CHARTER TOWNSHIP OF GARFIELD
PLANNING COMMISSION MEETING

Charter Township of Garfield Planning Department Report No. 2018-69			
Prepared:	June 26, 2018	Pages:	Page 1 of 6
Meeting:	July 11, 2018 Planning Commission	Attachments:	<input checked="" type="checkbox"/>
Subject:	Aspen Pines Multi-Family Residential Special Use Permit-Introduction		
File No.	SUP-2018-04	Parcel No.	05-340-026-10
Applicant/Owner:	Sean McCardel Construction, Inc.		
Agent:	Petra Kuehnis, Mansfield Land Use Consultants

Aspen Pines

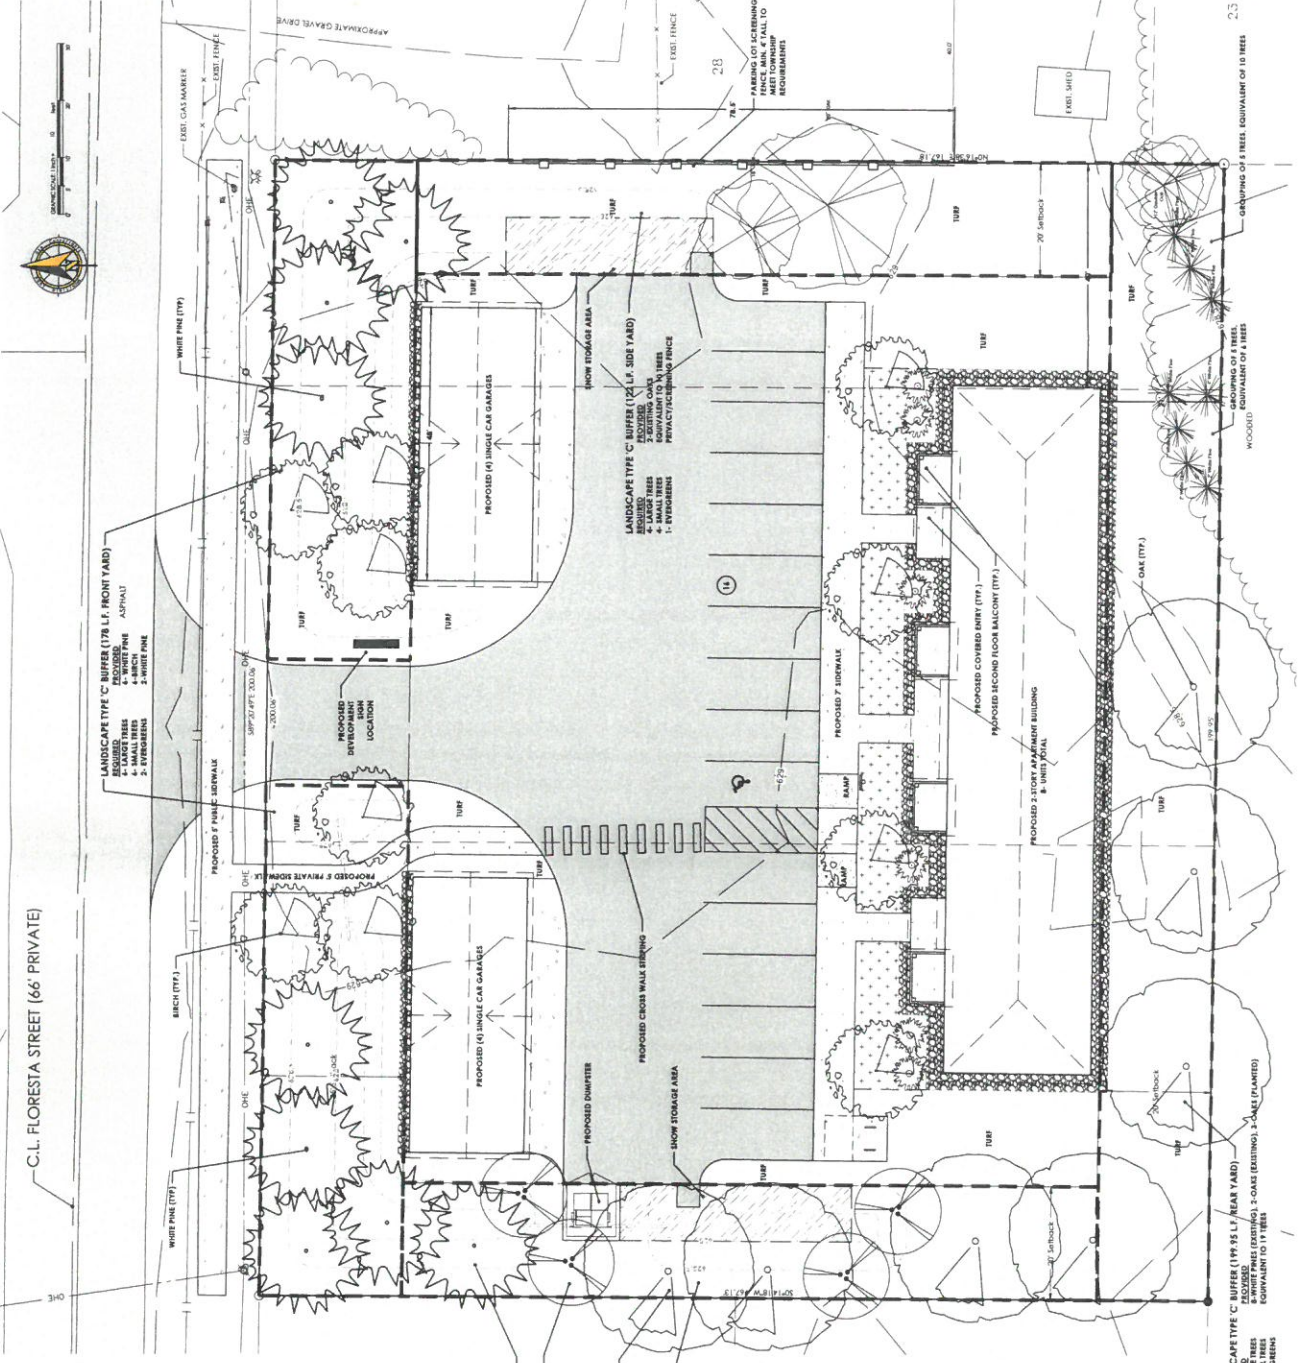
Second, the crediting of the existing trees clustered at the southeast corner of the property leaves the south and east lines relatively bare in comparison to the west and north lines. The intent of the Ordinance is to create continuous buffers with the plantings dispersed across the buffer-yards. In addition, it appears that the proposal credits the existing cluster of trees for both the south and east yard requirements, but the trees are really located within the south buffer yard.

As a Special Use Permit, the Planning Commission does have the authority to require additional landscaping at any location if determined to be necessary to meet the intent of the Ordinance. An updated landscaping plan that complies with the Ordinance will be required prior to a public hearing being held.

In light of the definition above, it does not appear that the applicant's proposed open space (Sheet C1.1) meets the requirements or intent of the Ordinance. For example, the side-yard areas may not exactly be "usable park-like areas." Commissioners may want to discuss this issue. Staff is of the opinion that this standard could be met with a simple redesign as well.

1. An updated site plan indicating that the dumpster area no longer encroaches into the setback area.
2. Additional detail regarding the maneuverability of emergency vehicles within the site.
3. An updated landscape plan indicating full compliance with the requirements of the Zoning Ordinance.
4. An updated site plan containing a note that makes clear that the detached garages shall not be used by nonresidents for self-storage purposes.
